GOVERNMENT OF THE DISTRICT OF COLUMBIA
DEPARTMENT OF TRANSPORTATION

MEMORANDUM

SUBJECT: ZC Case No. 08-30C – 25 M Street, SE

Figure 1 Site Design and Access (Source: Grove/Slade Associates)

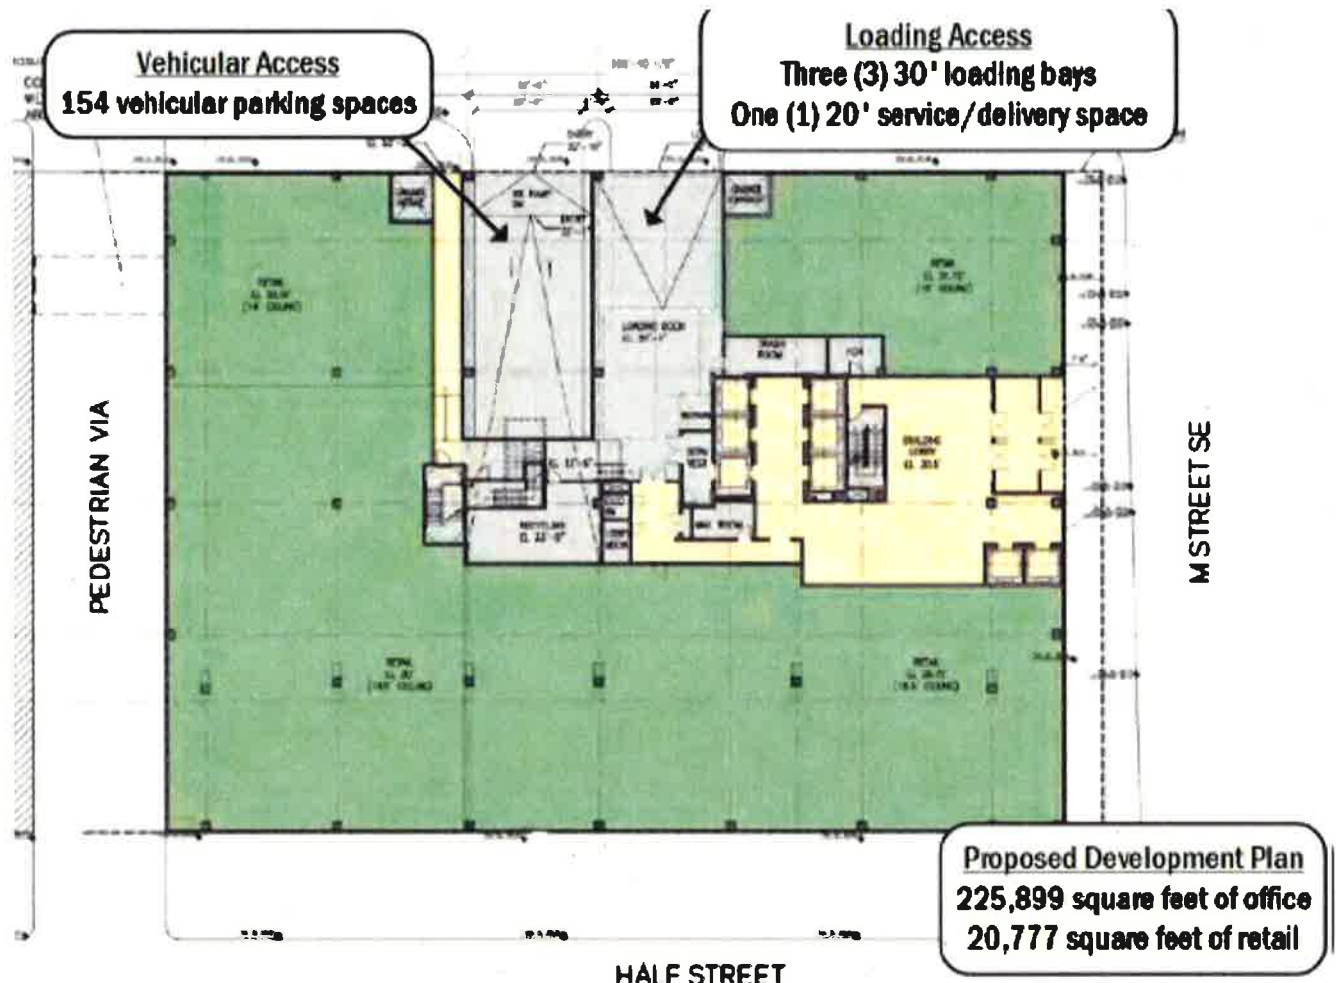
The Applicant proposes all vehicular access to the site on Van Street SE, which is a short local roadway between Half Street and South Capitol Street that connects M and N Streets. As shown in Figure 1, two curb cuts are proposed to provide vehicular access to the site. The northernmost curb cut will serve as the loading access for the office and retail uses and the southernmost curb cut will serve for vehicular and bicycle parking access.

The location of the two curb cuts does not meet DDOT standards for minimum distance between curb cuts. As proposed, the curb cuts are separated by 6 feet. DDOT's minimum distance between commercial curb cuts is 32 feet, but DDOT will support a separation of 24 feet, which has been approved for other curb cuts on Van Street. This minimum distance is significant because it will reduce conflicts, particularly as the design of the loading facilities results in back-in maneuvers, and will enable the planting of an additional street tree. This could affect the square footage of ground floor retail and thus compliance with the zoning requirements for ground floor preferred retail (§1607.3).

DDOT does not support the 6 foot separation of curb cuts on Van Street. DDOT expects the Applicant to revise their plans to show the two curb cuts with a minimum separation of 24 feet and apply for the appropriate public space permits.
